ADDENDUM NO. 3

**SDOC-06-074-FPC
ROOF REPLACEMENT REBID
OSCEOLA COUNTY SCHOOL FOR THE ARTS
3151 North Orange Blossom Trail
Kissimmee, Florida 34744
SCN: 0921**

**DBYA: 05-134
Date: April 13, 2006**

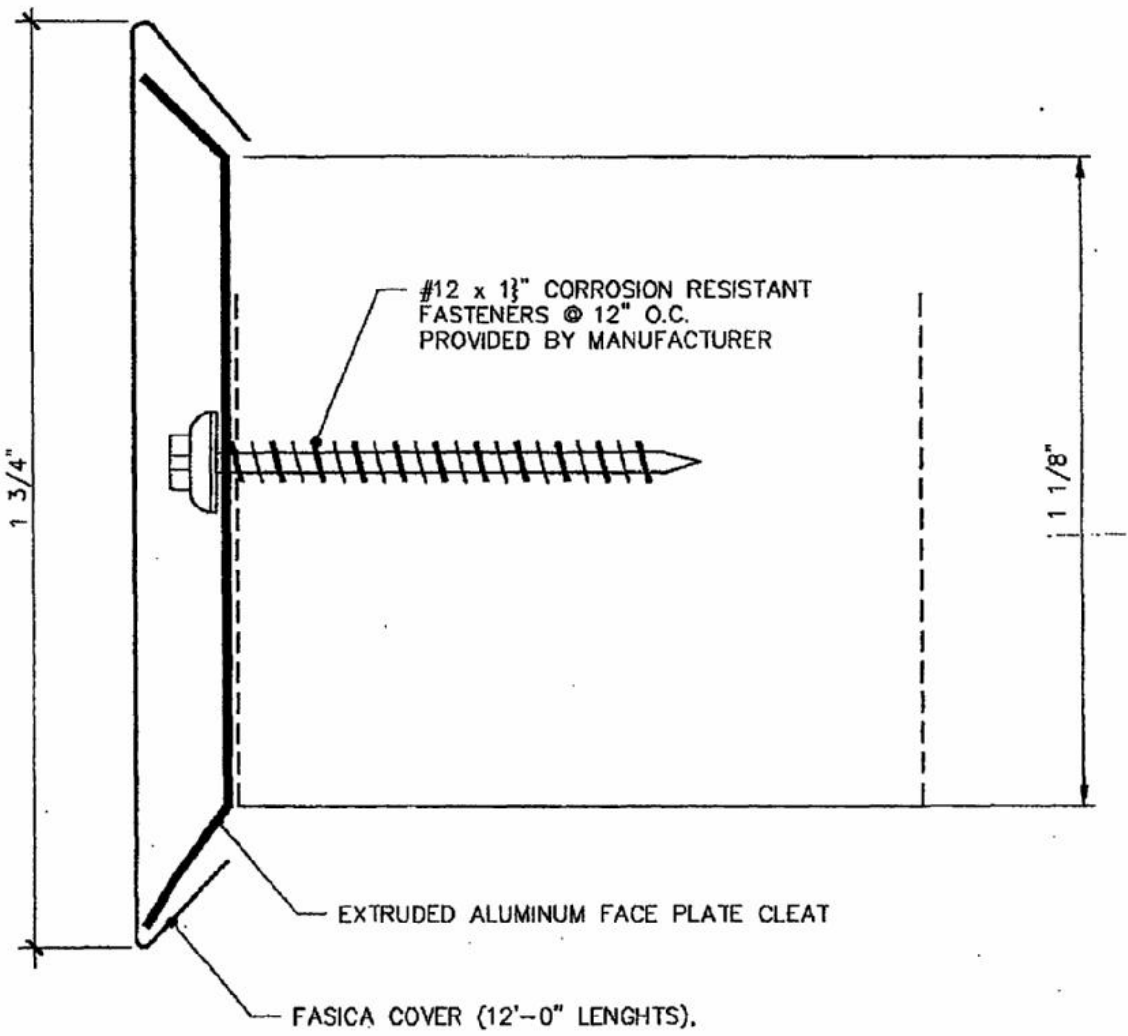
- ADD.3.16: Detail 26, DELETE reference to DETAIL 26.
- ADD.3.17: Detail 27, DELETE and REPLACE with new DETAIL 27 REVISION NO. ADD 3 attached herein.
- ADD.3.18: Details 37 and 38, ADD Note: OWNER RESPONSIBLE FOR ALL WORK AFFECTING REFURBISHMENT OF EXISTING CHILLED WATER LINES - CONTRACTOR RESPONSIBLE FOR ALL WORK AFFECTING WEATHER TIGHTNESS AT WALLS AS DETAILED.
